April 3, 2024

IDEA Public Schools Upper RGV Mechanical Upgrades CSP#23-URMU-0424

ADDENDUM NO. 2

ME4.2

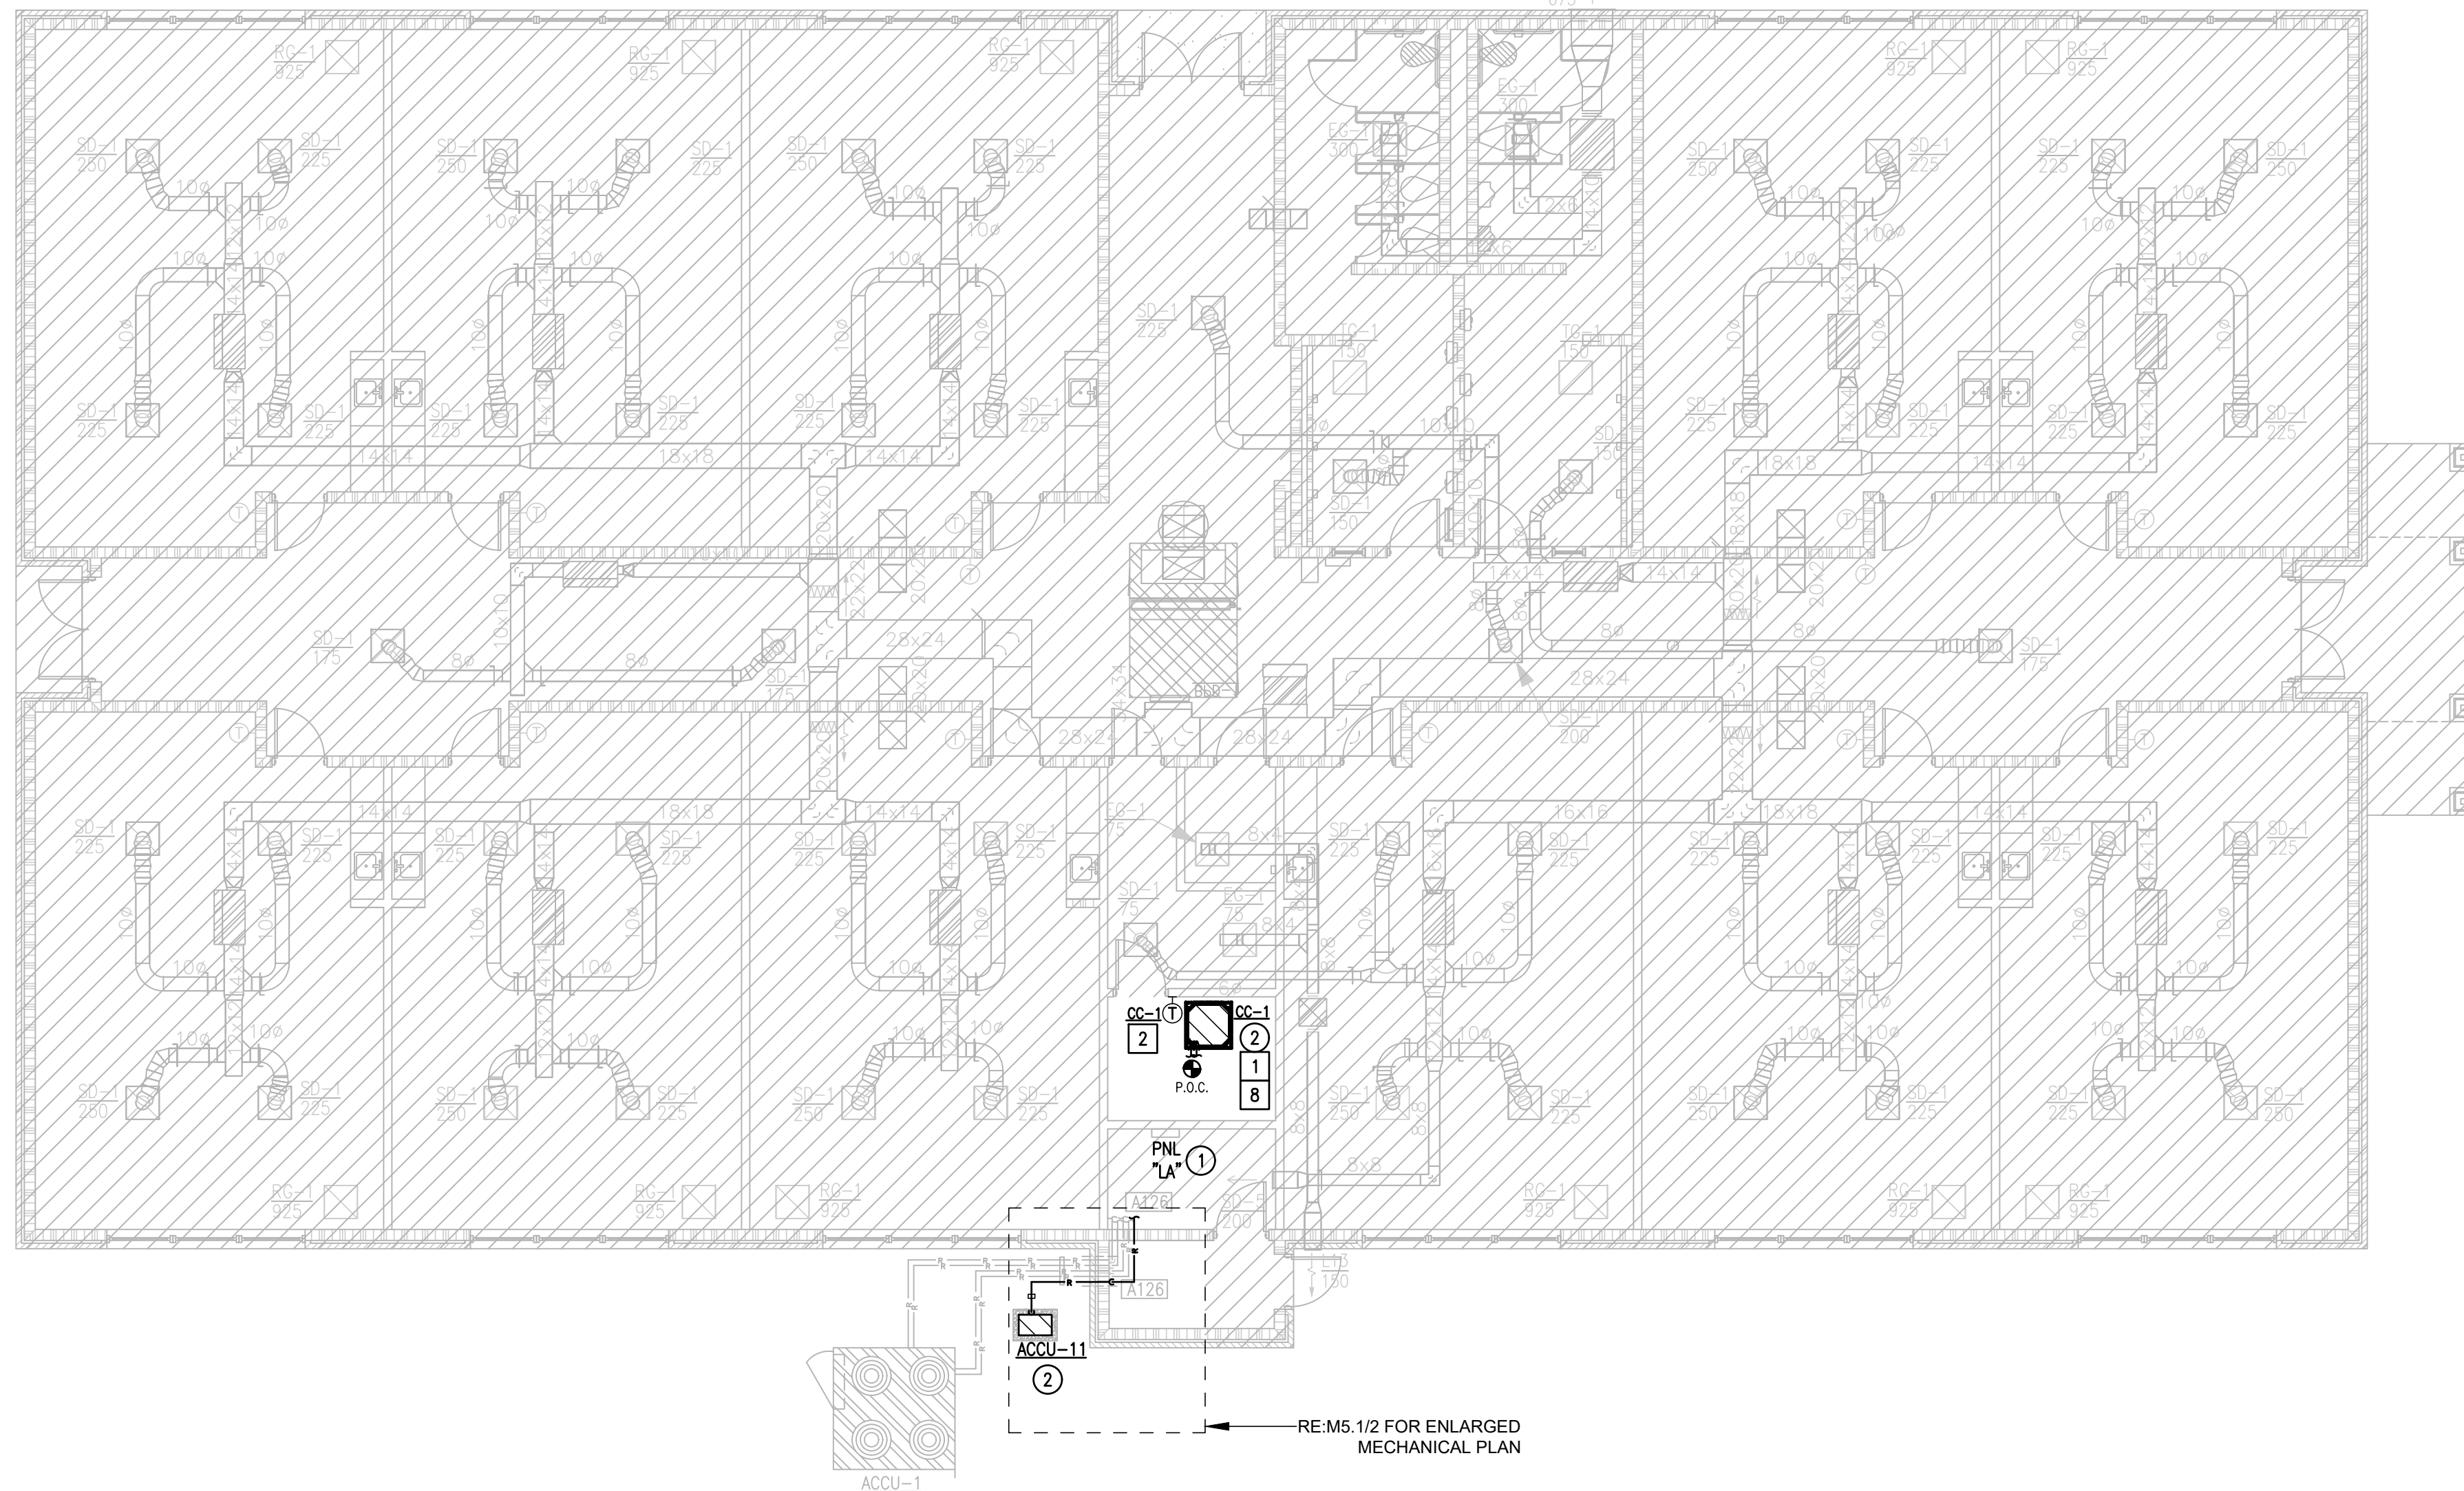
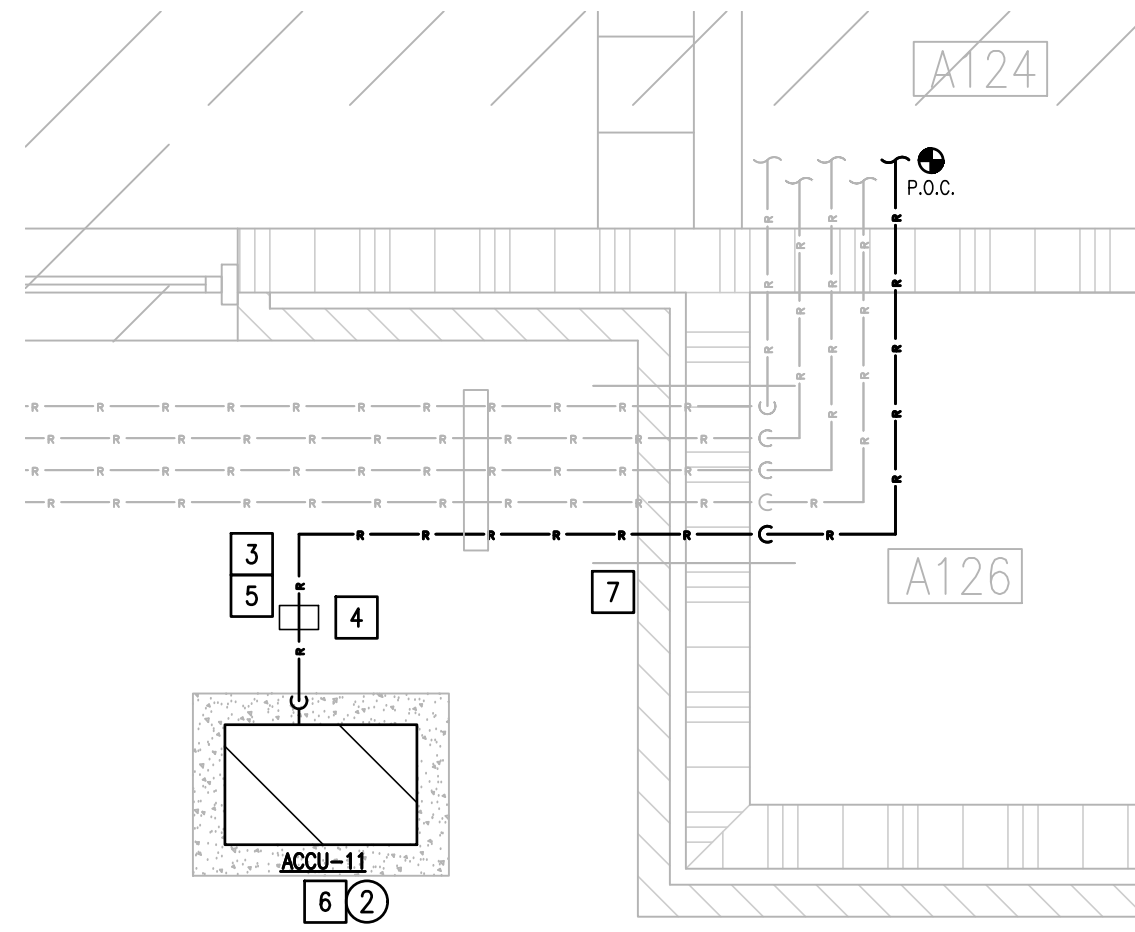
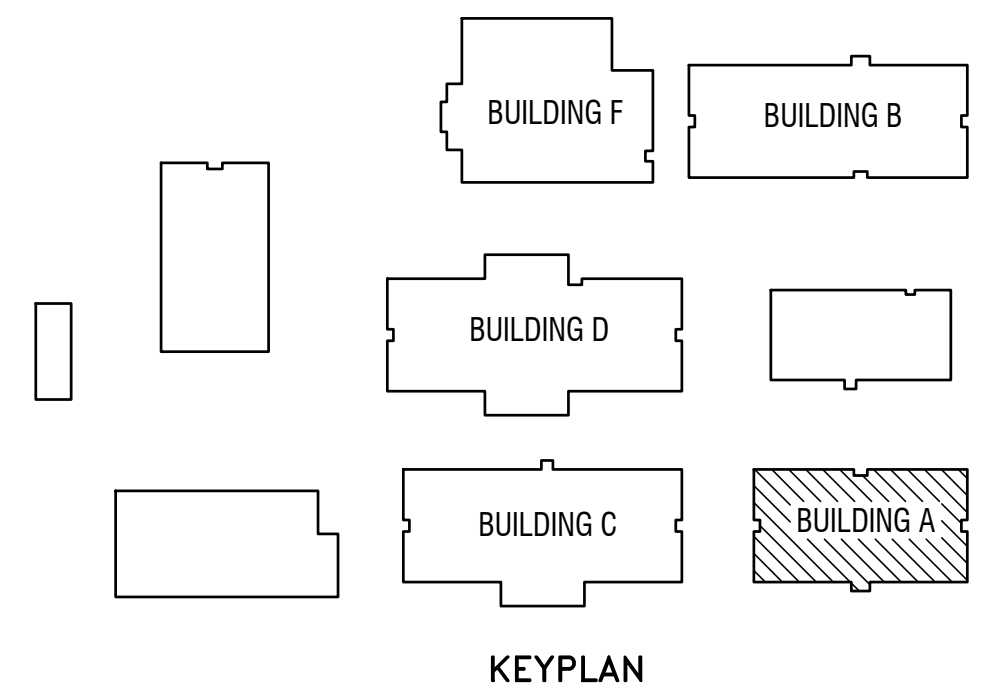
- b) Roof patch work shown for RTU-B4.
8. Sheet ME-4.2 – See attached.
 - a) Added Base Bid identification to schedules.
9. Sheet ME-5.1 – See attached.
 - a) Added Base Bid identification to schedules.
